CHARLOTTE HISTORIC DISTRICT COMMISSION CERTIFICATE OF APPROPRIATENESS - AMENDMENT

CERTIFICATE NUMBER: 2017-00364

5 June 2019 - AMENDMENT

ADDRESS OF PROPERTY: 1508 Dilworth Road

Photo Showing Top of Wall Where Limestone Coping is Missing at Rear of Brick Parapet

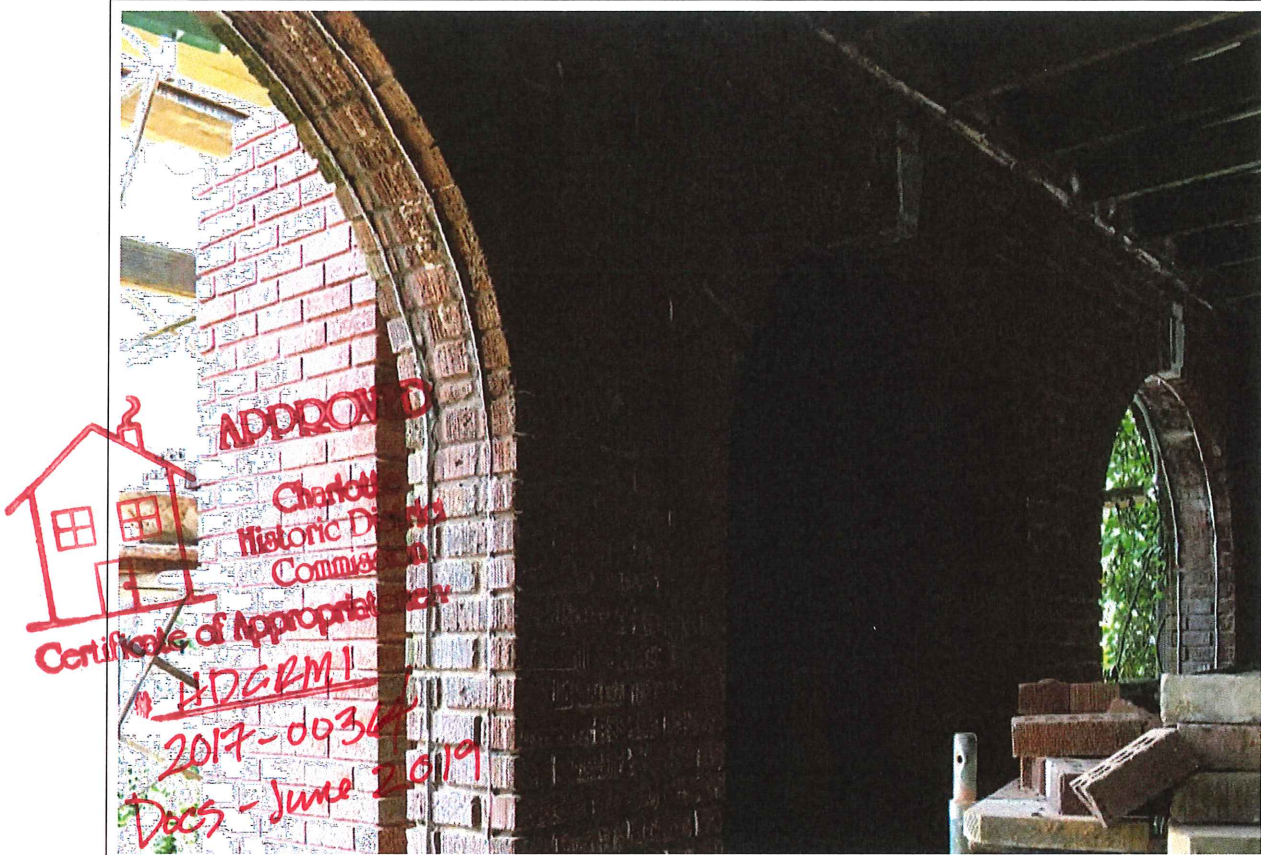
Photo Showing Existing Flashing at Back of Brick Feature

This flashing does not extend through the wall, and exposed mortar joints at top of wall allow water intrusion

The degraded mortar and holes in the brick allow water to seep through the wall to the interior of the house

Diagram Showing Existing Water path and Proposed Flashing

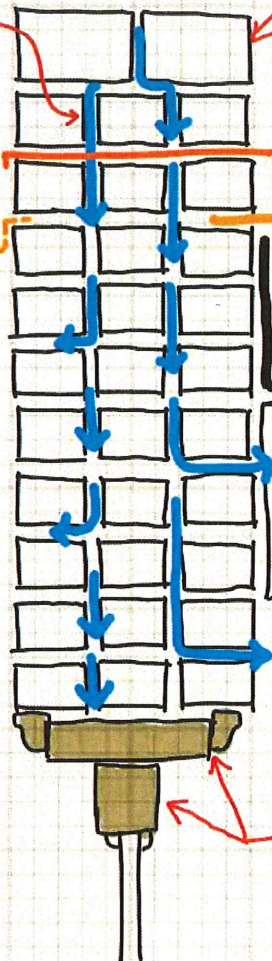
Water is coming
THROUGH the
masonry joints

~~New Flashing
Cut & walked into
Mortar joint
will not stop
water infiltration~~

Thru-wall Flashing Req'd to stop water

Per your email approval dated 03/20/2019 addressed to Audry Barber of Ruard Veltman Architecture, Inc; the existing limestone cap and masonry feature will be removed and saved for re-use. A copper flashing will be installed over the brick wall with a 0.25" turn down at exterior. The limestone cap will be replaced, and the masonry feature re-constructed exactly as it was.

* 1/4" turndown @
face of brick
